### ADDENDUM

PROJECT TITLE: PUBLIC SPACE AT MARKET SLIP & HARBOUR PASSAGE EXTENSION	ADD. NO: 1
TENDER NO: 2022-081201T	DATE: June 30th, 2022
PAGE 1 of 2 (Including Confirmation Sheet)

Public Space at Market Slip & Harbour Passage Extension

ADDENI	OUM NO:	<mark>1</mark>
DATE	June 2	27, 2022
PAGE	1	OF 6
CONTRA	ACT NO:	2022-081201T

DATE I MINIED.	DESIGNED DT.	
10.06.2022	DG	
DRAWN BY:	CHECKED BY:	
CT	DG	
CLIENT PROJECT No.:	GG PROJECT NO:	
2022-081201T	2107	
SCALE:	DATE:	
	10.06.2022	
SHEET NUMBER		
A5

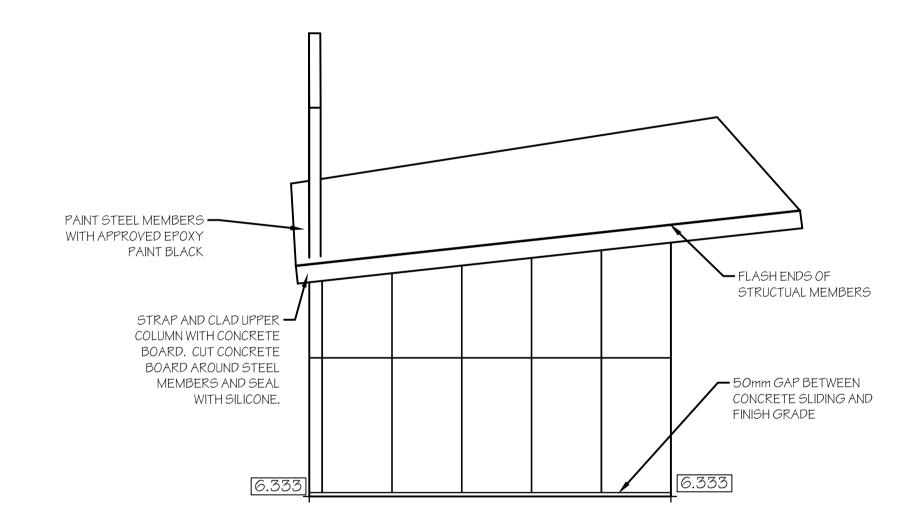
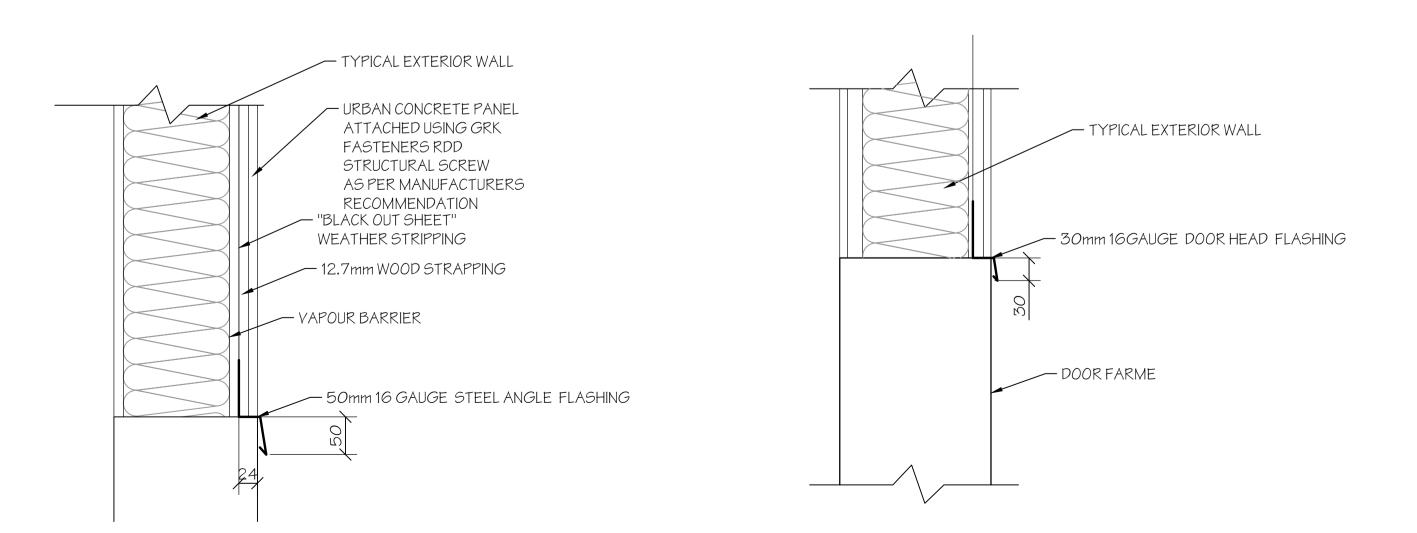
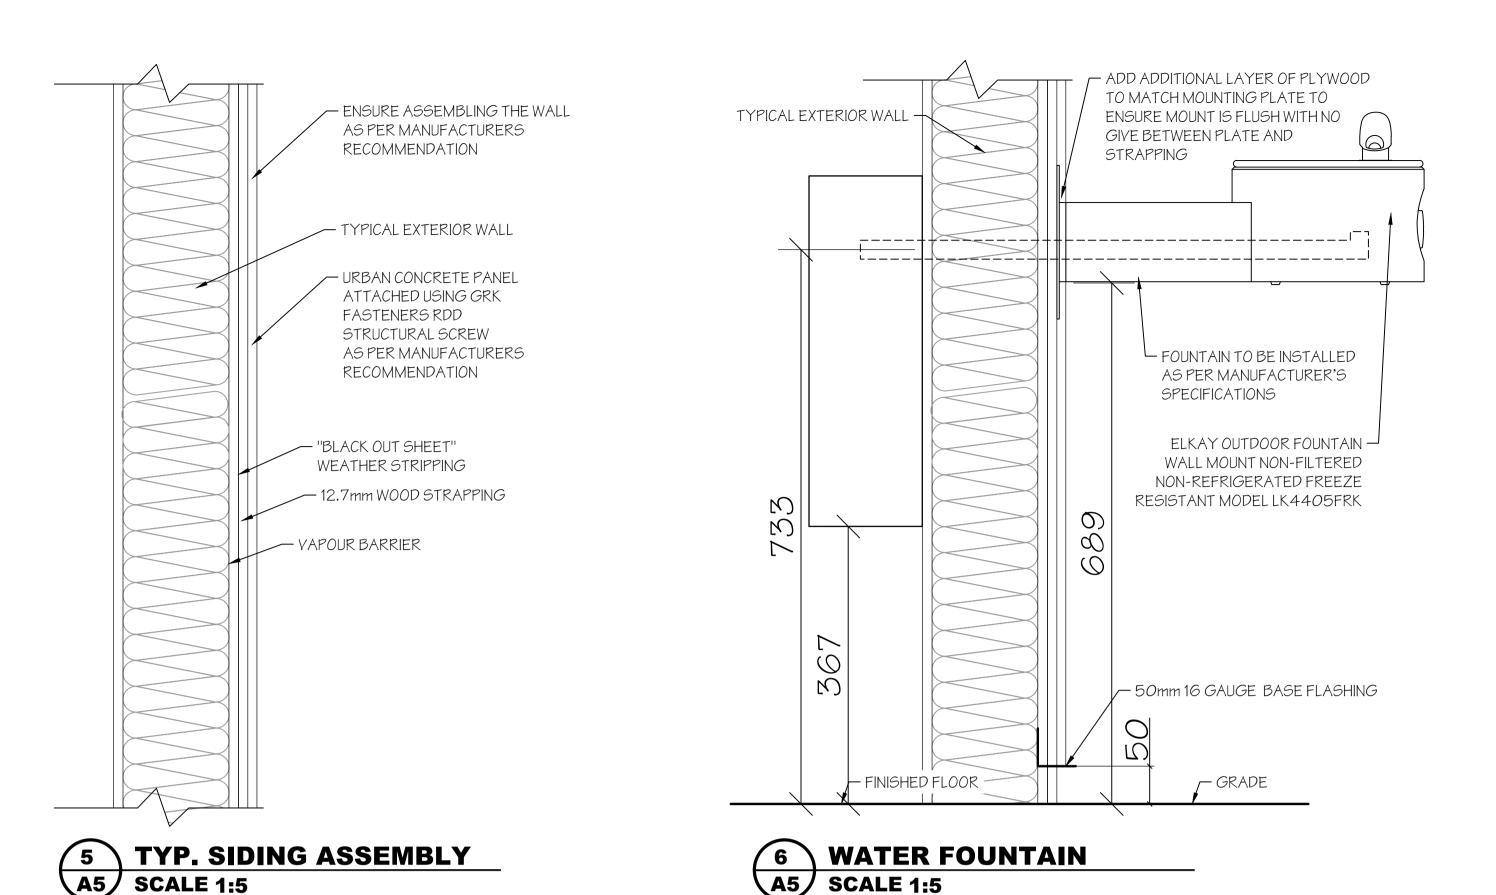
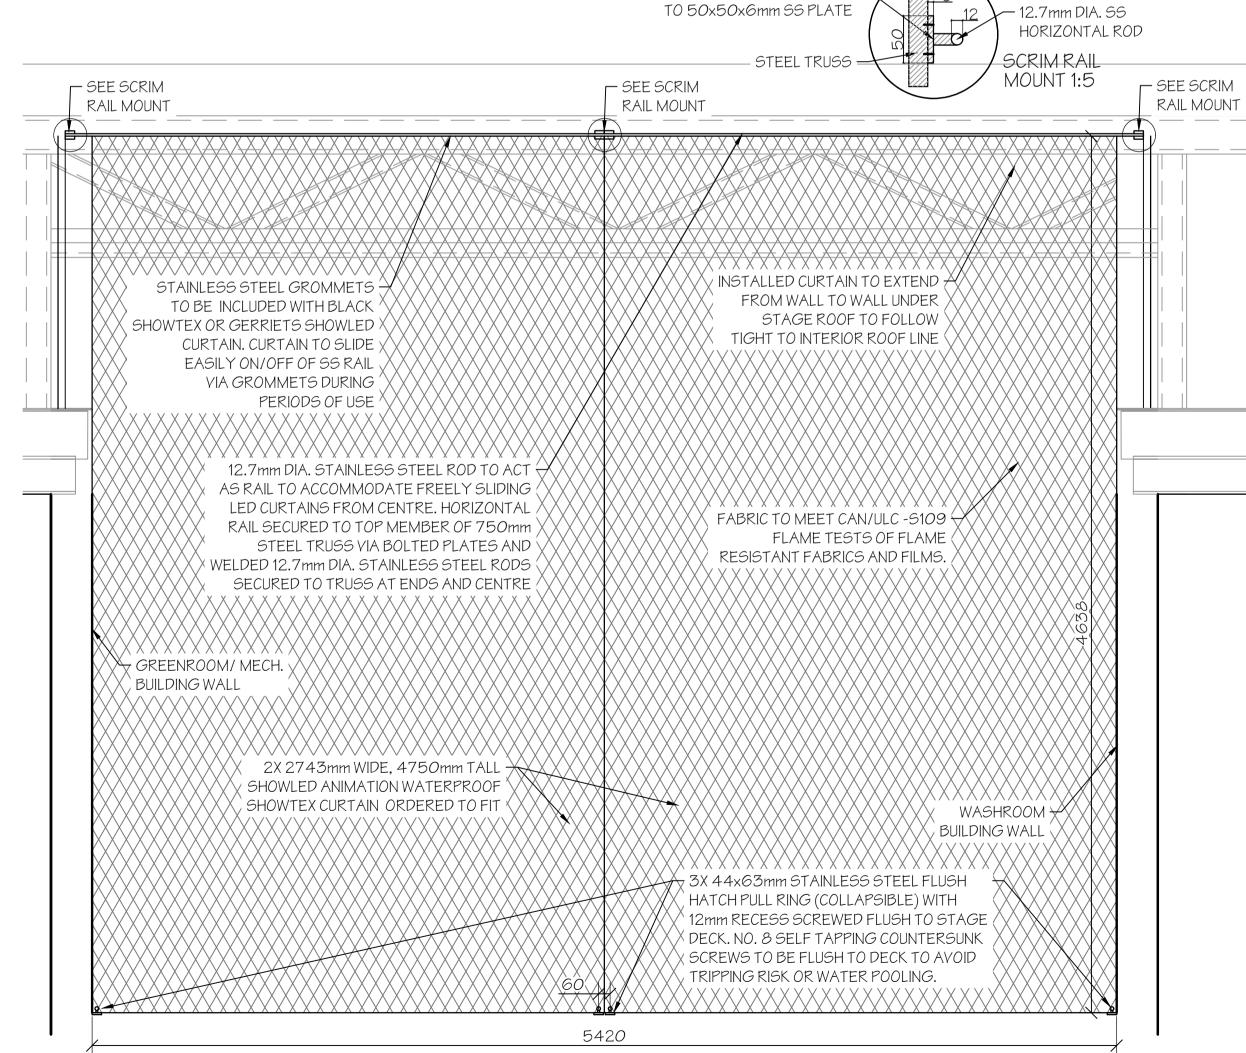
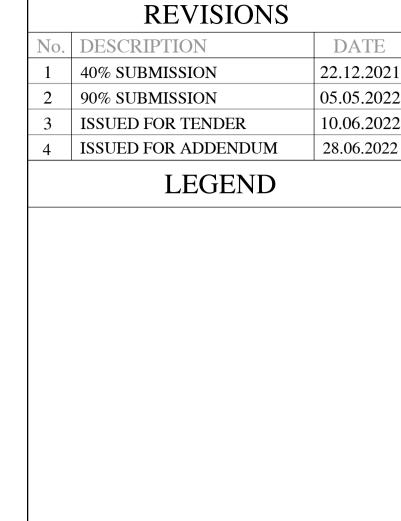
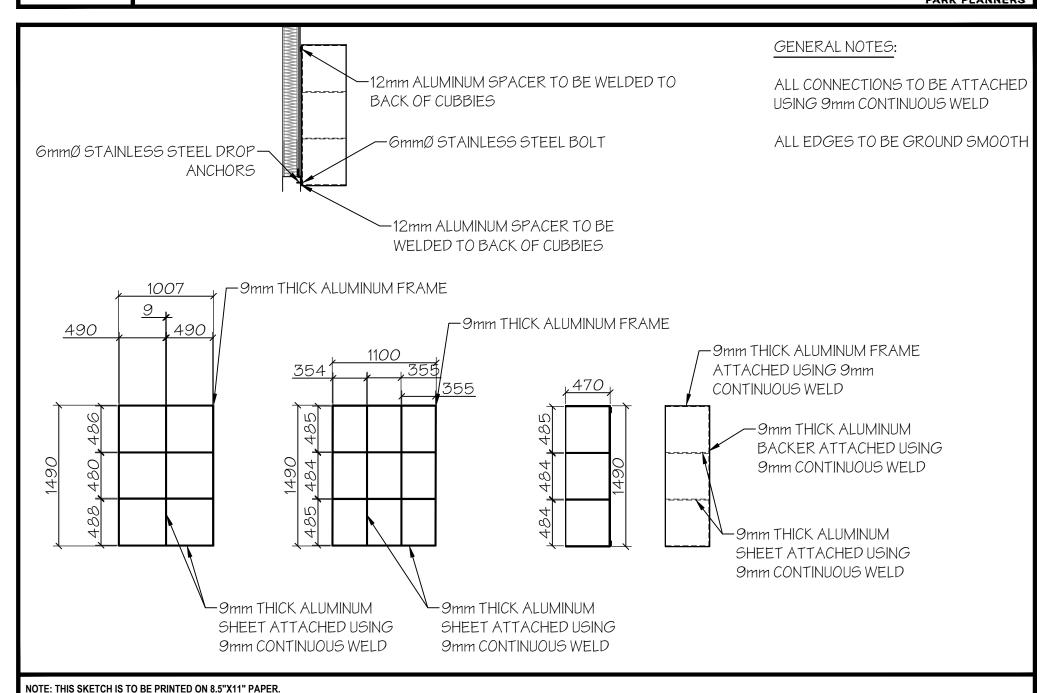
On sheet A4 contractor to modify elevation views of building to accommodate 50mm gap between concrete siding and finish grade as noted on A4 – Issued for Addendum Revision 4.

On sheet A5 contractor to modify details 3-A5 to show flashing at bottom of grade. Modify details 4-A5 to door head flashing. Modify 7-A5 – perforated win screen attachment. A4 – Issued for Addendum Revision 4.

TITLE: SHOE CUBBIES DATE: JUNE 27, 2022 DRAWN BY: MB SCALE: 1:40

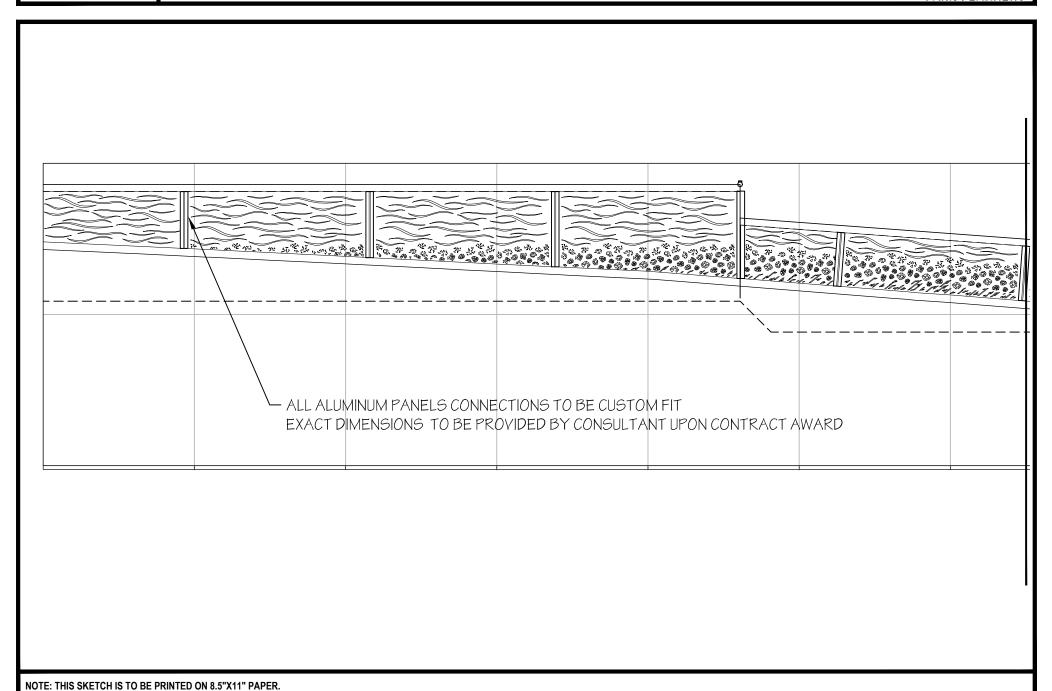
ASK1 – Shoe Cubbies – Please add ASK1 to drawing package. Please include the cost of this under the lump sum pricing for the building.

TITLE: ISLAND # 2 PROFILE "A" PANEL PATTERN

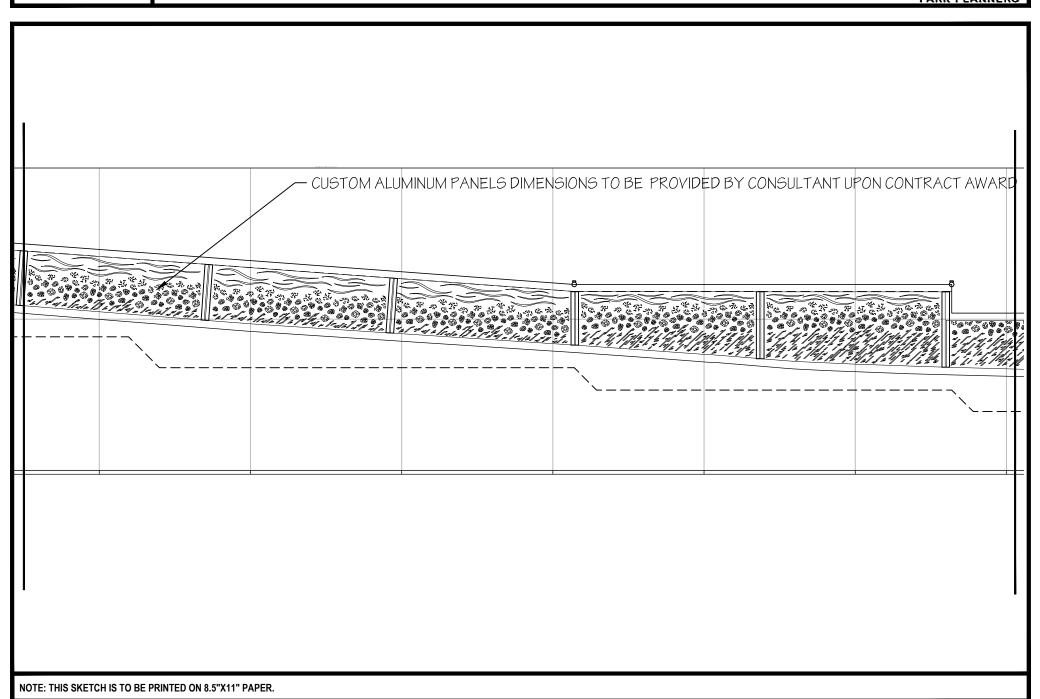
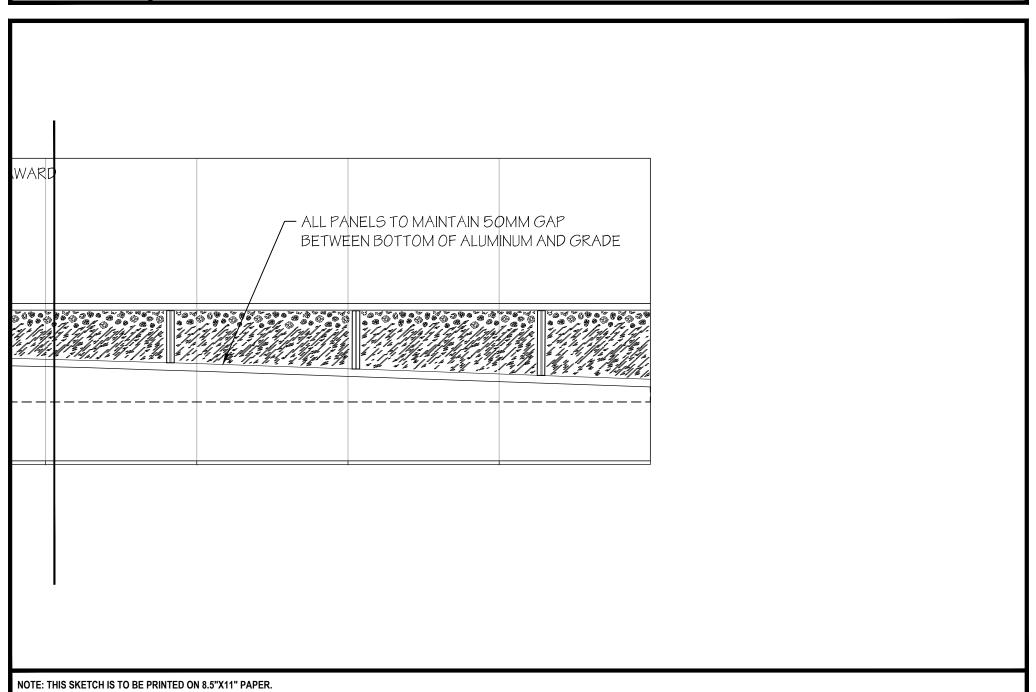
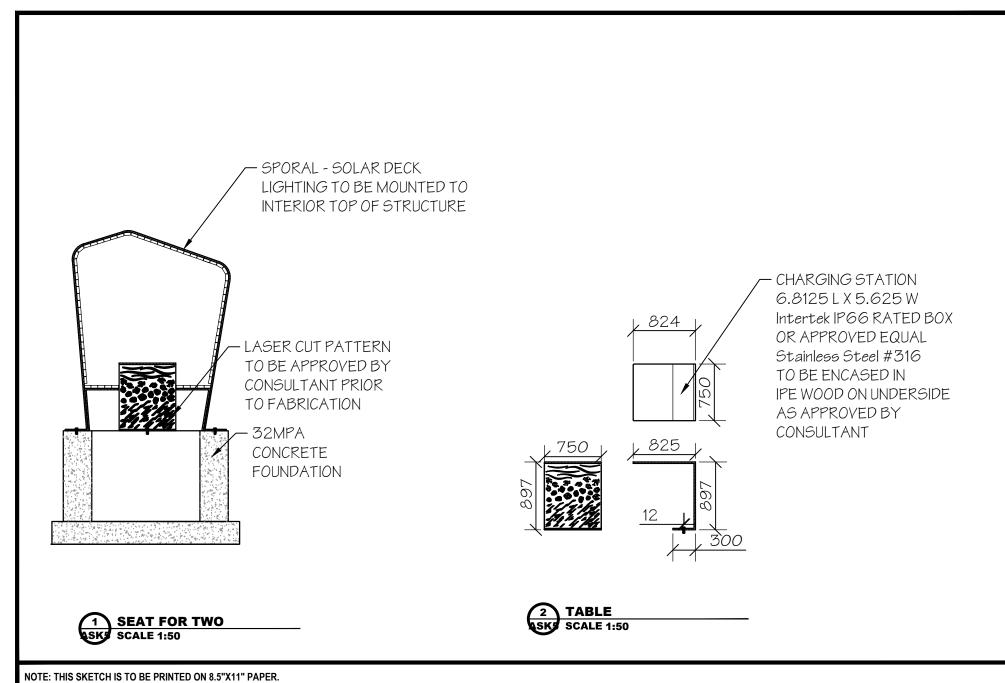
ASK2 to 4 – Added profile view example of custom laser panels on curved aluminum walls. Example is for island number two only. Future profiles of all walls will be completed for contract award. Electronic files to be provided upon contract award.

TITLE: TABLE FOR TWO DATE: JUNE 27, 2022 DRAWN BY: MB SCALE: AS SHOWN

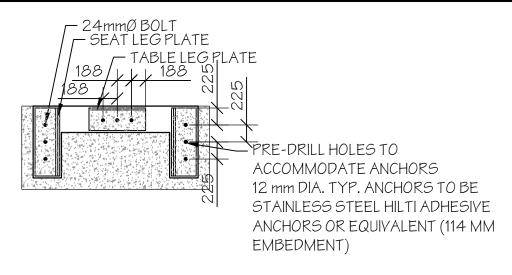
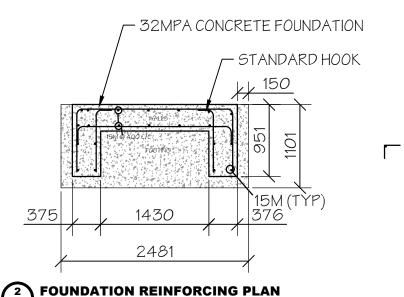
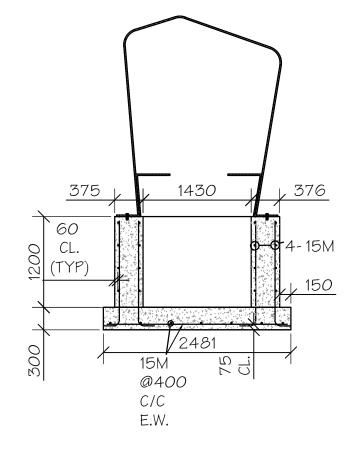
ASK5 – Table for Two – Please add ASK5 to drawing package. The drawing includes a laser cut pattern. Please add sporal solar lights to roof of structure – 2 per.

ASK6 – Table for Two – Please add ASK6 to drawing package. Please include reinforcing information indicated on ASK6.

TITLE: INTERPRETIVE SIGNAGE

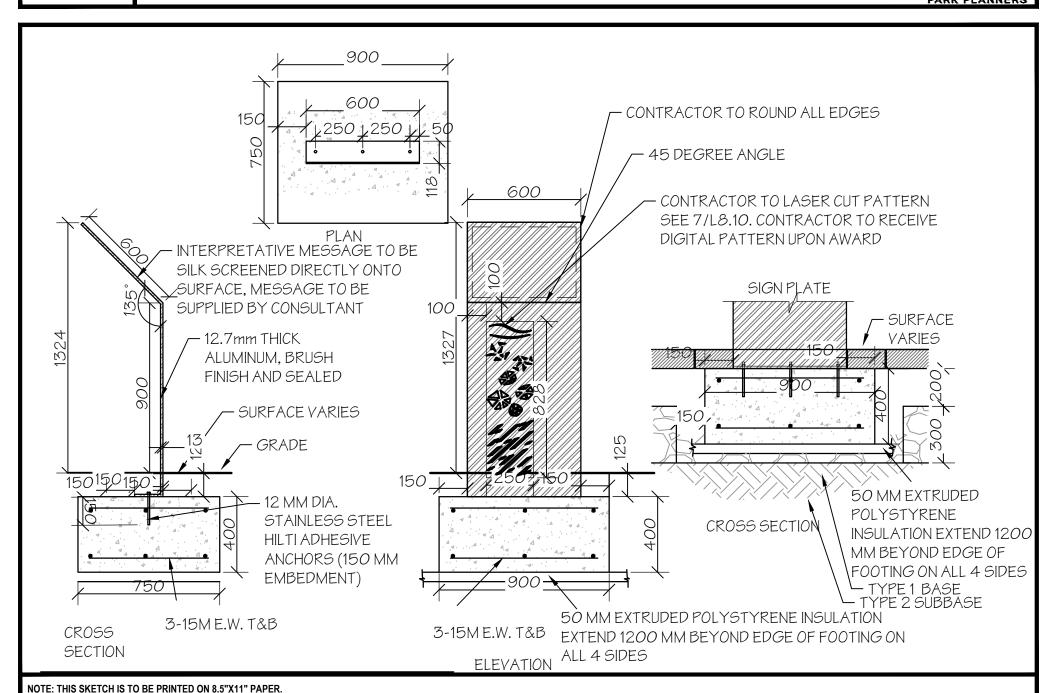
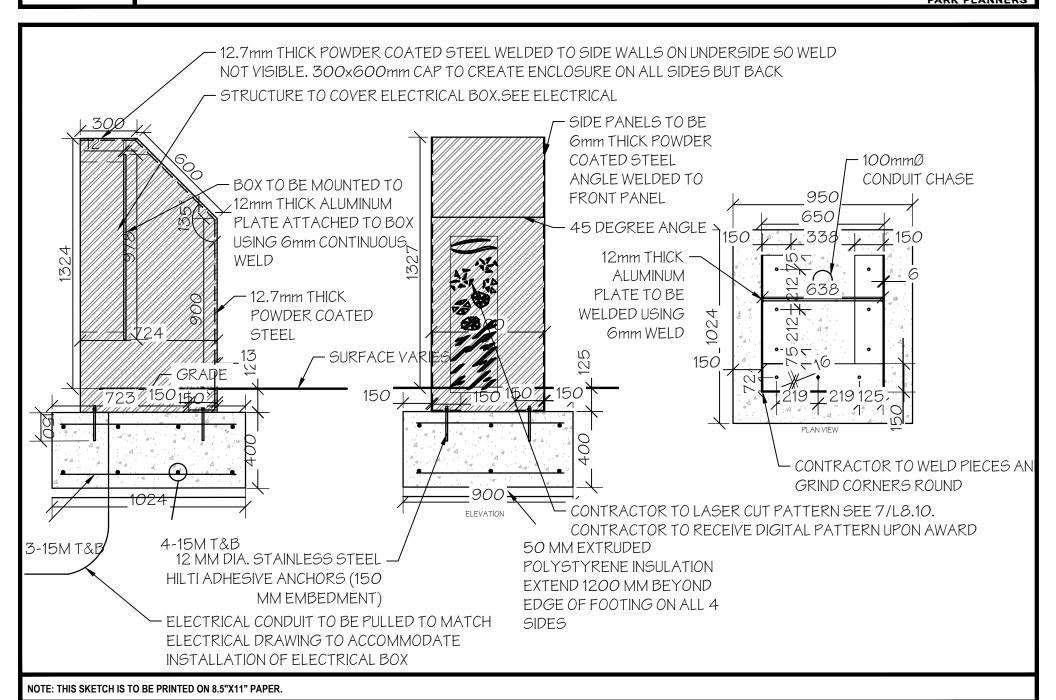
ASK7 – Interpretive Panel – Please add ASK7 to drawing package. Please include reinforcing and laser cutting pattern as indicated.

ASK8 – Interpretive Panel – Please add ASK8 to drawing package. Please include reinforcing and laser cutting pattern as indicated.

TITLE: GAMES TABLE DATE: JUNE 27, 2022 DRAWN BY: MB SCALE: 1:40

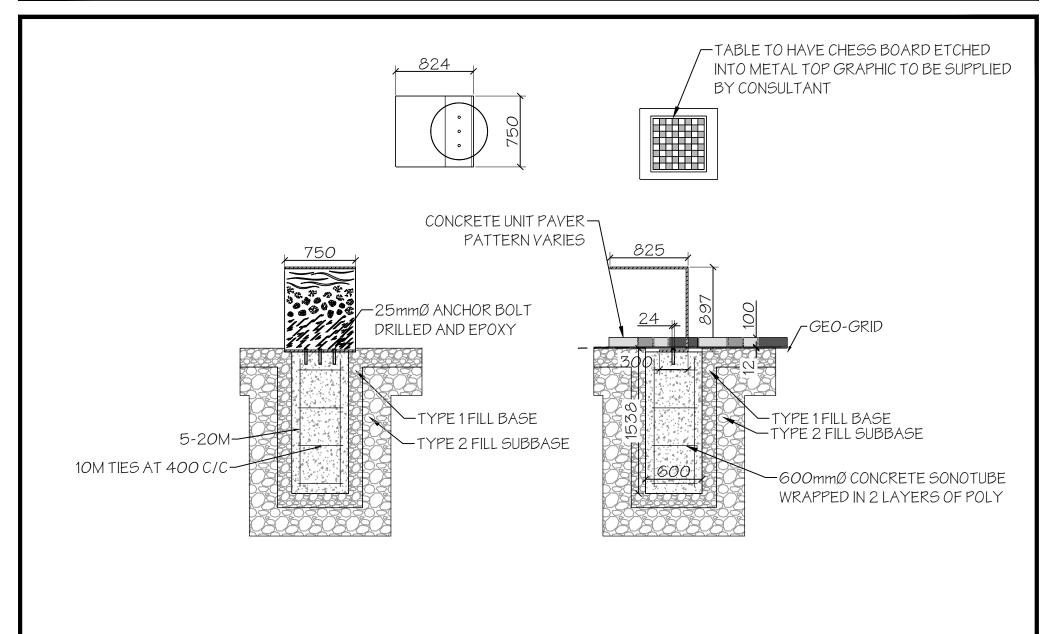
ASK9 – Games Table, laser cut pattern to backside of aluminum table to be incorporated with 1 – LS1.6.
